PLANNING COMMISSION
DATE: 9/8/14
AGENDA ITEM: 4A – PUBLIC HEARING ITEM
CASE # 2014-43

ITEM: Village Park Preserve Residential Subdivision – Preliminary Plat

SUBMITTED BY: Nick Johnson, City Planner

CITY PROJECT NO.	PRELIMINARY GRADING PLAN	FILE NO.
LAKE ELMO, MINNESOTA	VILLAGE PARK PRESERVE	3120-047
	GWSA LAND DEVELOPMENT	GP1
		GP5

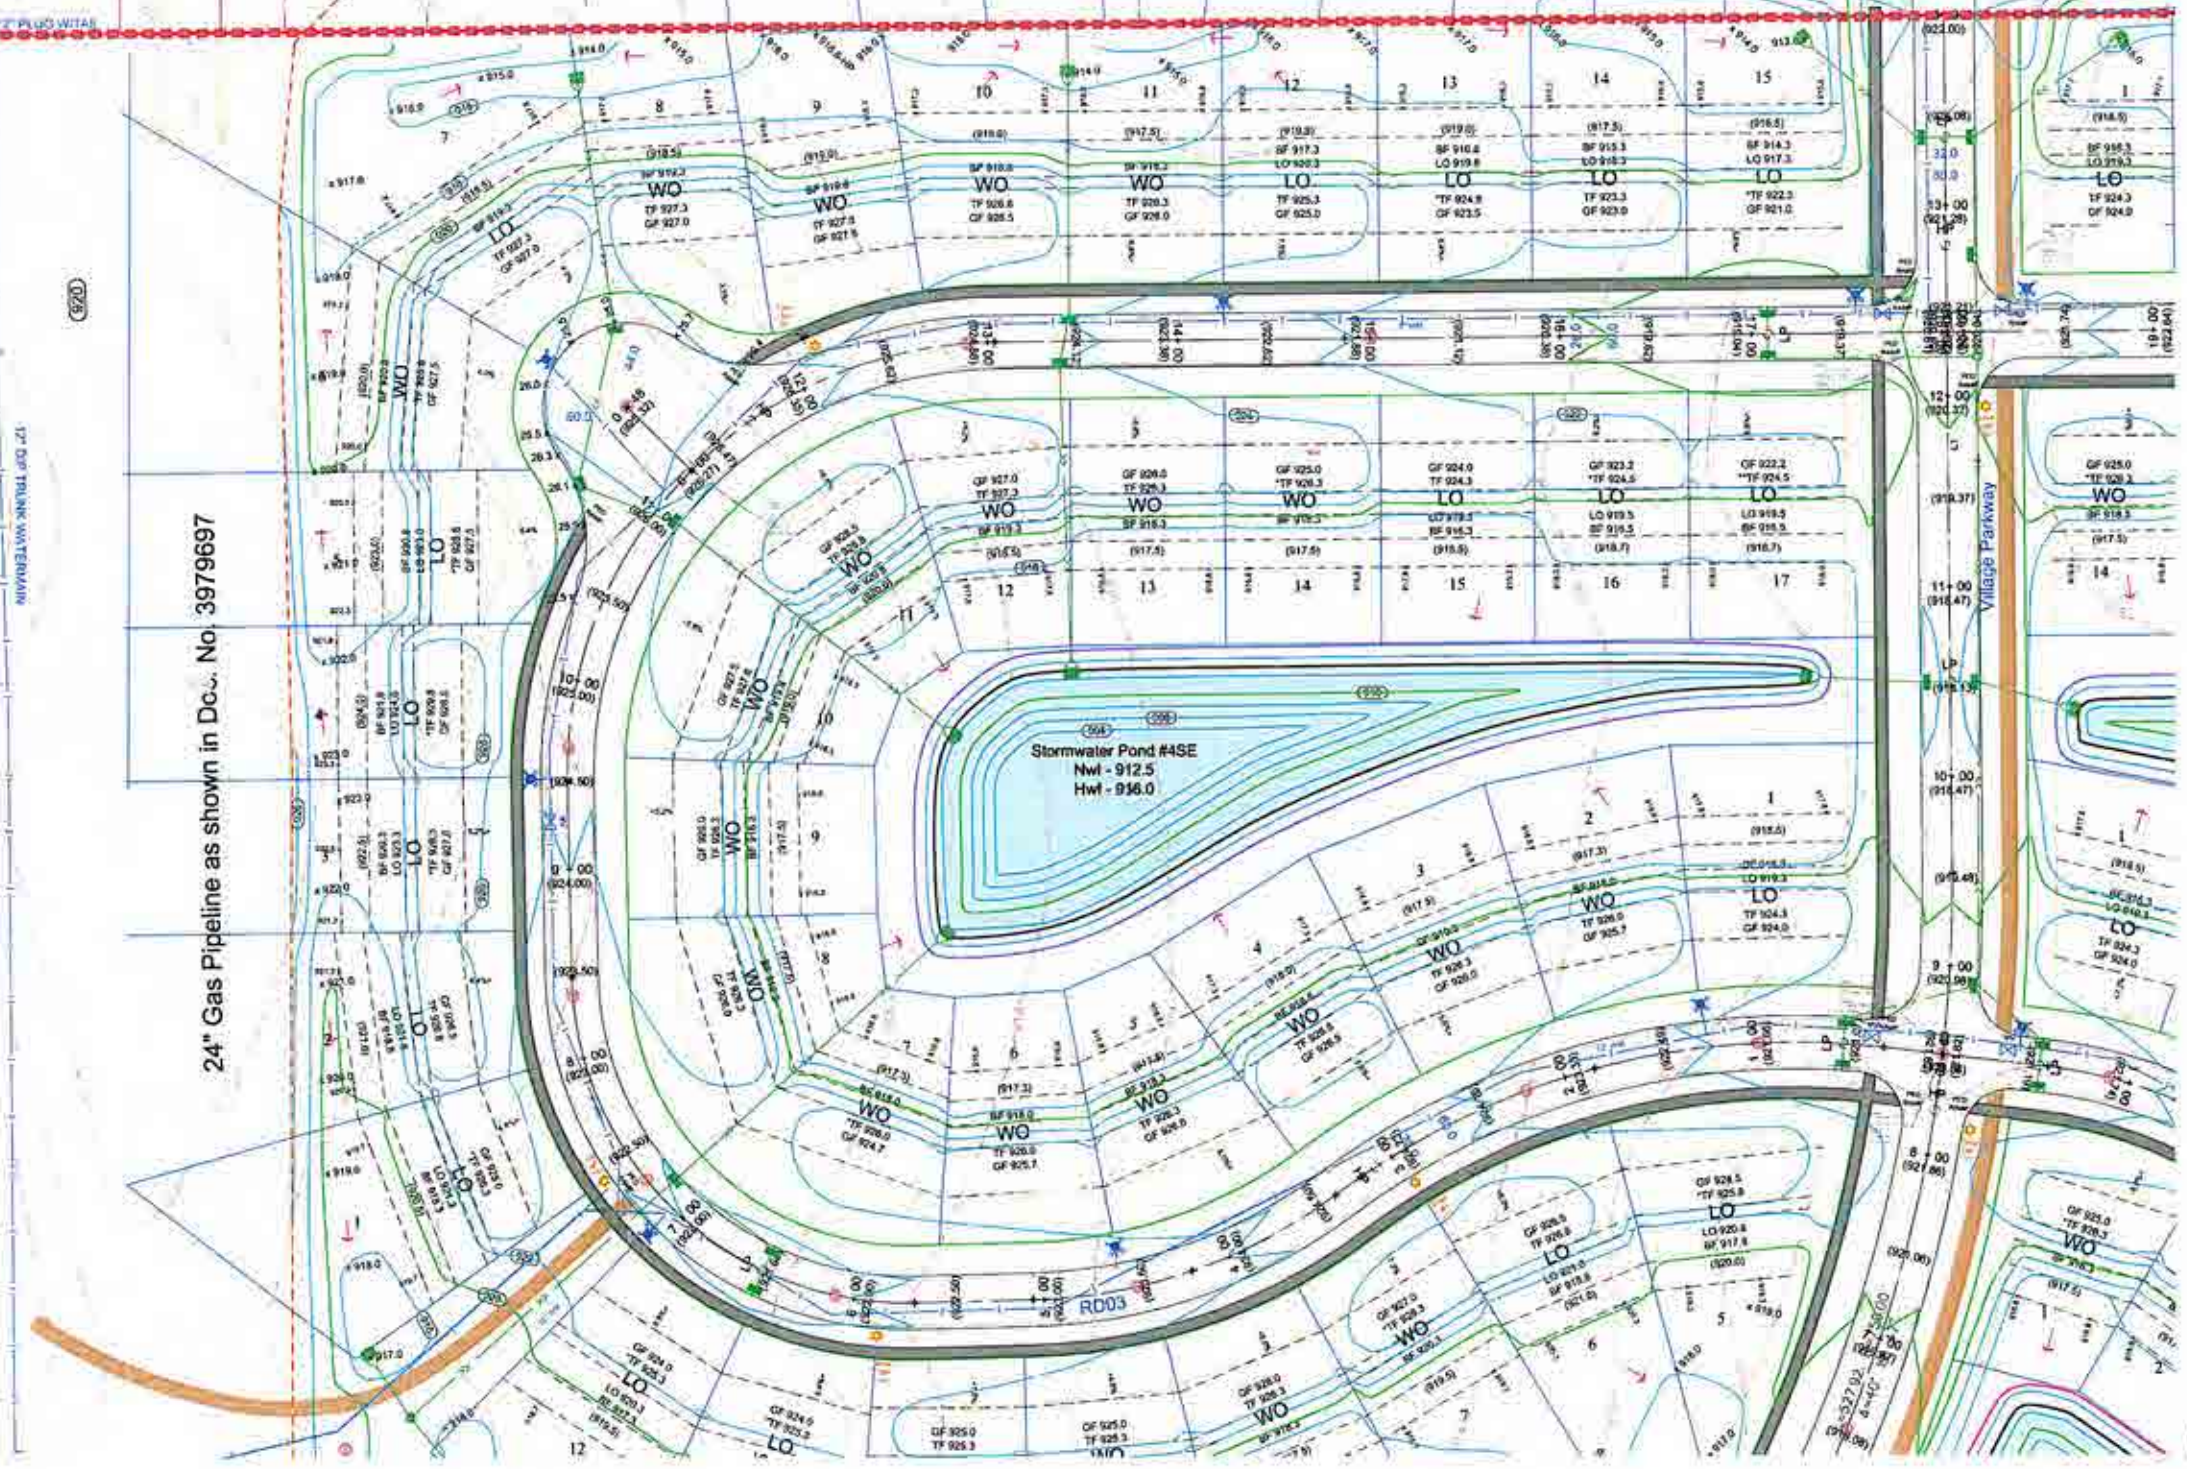
Discussion: State the maximum slopes on ponds, specifically 1SE, on the grading plans. Notes on sheet GP1 mention maximum of 4:1 slopes, but grading plans appear steeper than that. Slopes greater than 3:1 typically are not allowed, and depending on where water levels stabilize, this also impacts the appropriate slopes and where 10:1 safety benches are appropriate.

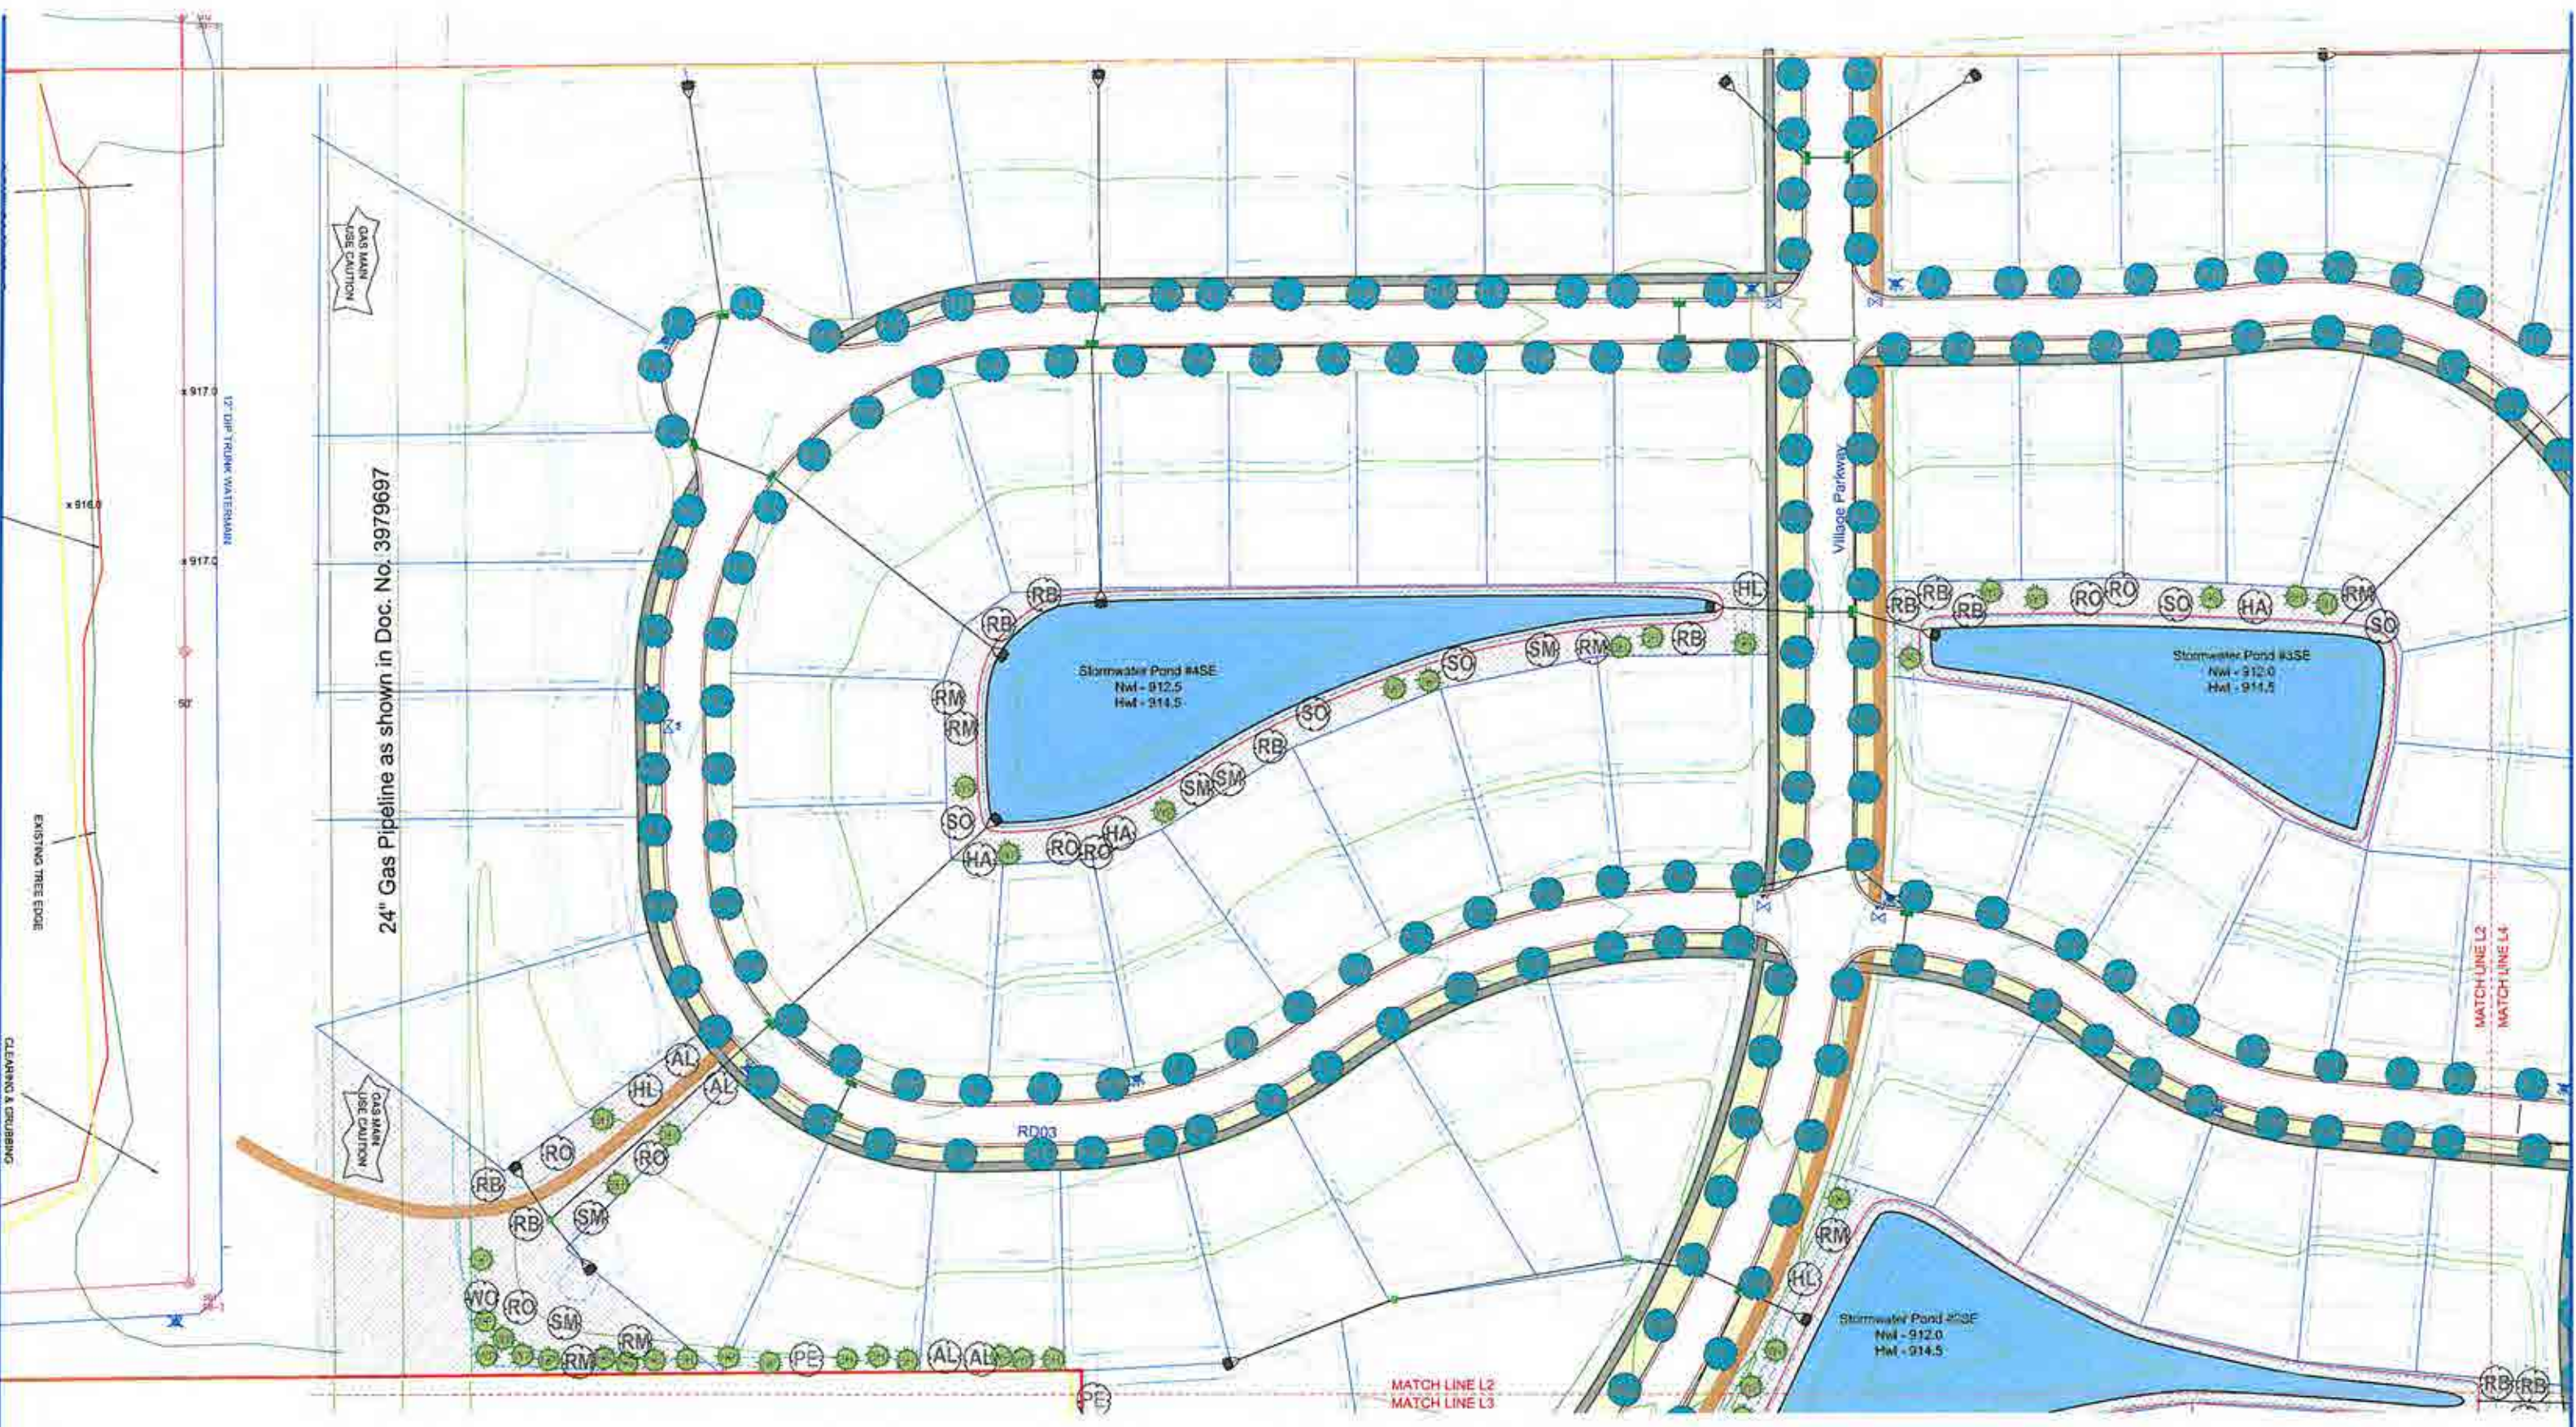
1. Provide your calculations for street frontage trees on sheet LP1.
2. Please represent planting areas within centers of Cul-de-sacs.
3. Provide temporary and permanent groundcover vegetation utilizing 100% native landscape plants for all lots, commonly held HOA & City R.O.W. areas with the exception of the areas noted to be sodded, irrigated and managed as traditional turf bed areas. Suggested native cover for proposed home lots could be Little Bluestem with the addition of some (10+ species) native wildflowers depending on aesthetic look desired (all blue flowers, mix of flowering times, etc...). Suggested permanent native cover should provide the most appropriate ecologically correct mixes. A suggested example would be to reference the seed mixes offered by MN Native Landscapes (<http://www.mnnativelandscapes.com/>). Please provide the appropriate mix for each specific proposed landscape situation. For example the short dry upland mix for a non-irrigated upland outlot area where shorter grasses are desired adjacent to paths or streets.

- 9) The Landscape Plan shall be updated per the recommendations of the City's Landscape Consultant, describe in a memo dated September 4, 2014. Tree protection measures for trees intended to be saved according to the submitted Tree Survey must be included in the Final Landscape Plan.

1 SECTION LOOKING EAST FROM McLEOD PROPERTY
5 SCALE: 1"=20'

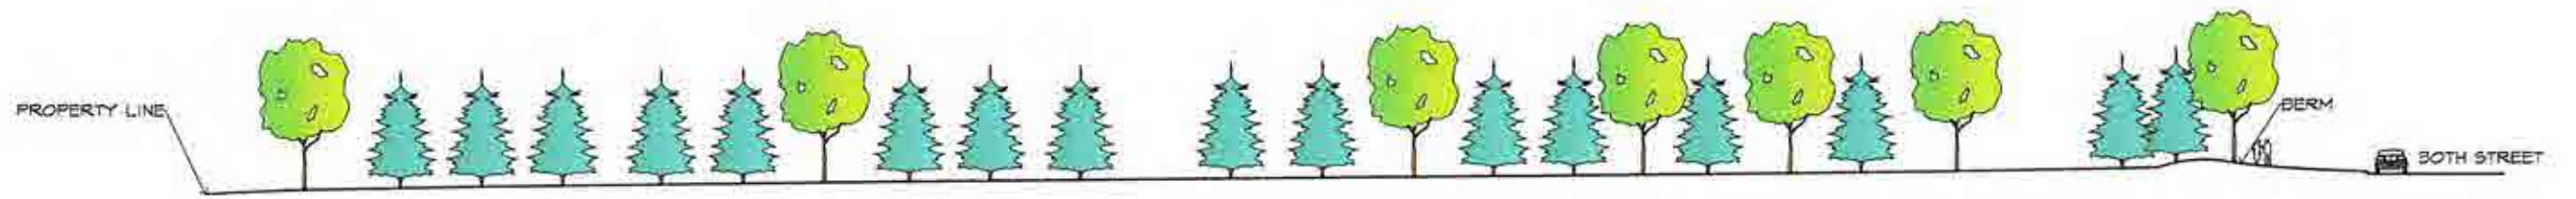
- **Mcleod Property.** In addition to the recommended buffering along 30th Street and Manning Avenue, buffering and screening around the Mcleod property in the southwest portion of the development, particularly the east boundary, is required as a condition of approval for the Comprehensive Plan Amendment (Resolution 2014-60 – Attachment #4). Once again, a more aggressive planting schedule has been provided around the east and north boundary of the Mcleod property, providing year round screening. In addition, the lots on the east side of the Mcleod parcel are of greater size and depth than most of the lots in the development. Nevertheless, staff would recommend that the applicant install an additional row of trees in the rear of 1-3, Block 1 to provide additional screening.

- 11) The applicant shall install an additional row of trees in the rear of Lots 1-3, Block 1 to provide additional screening for the eastern boundary of the Mcleod property to satisfy the condition of approval related to the requested Comprehensive Plan Amendment.
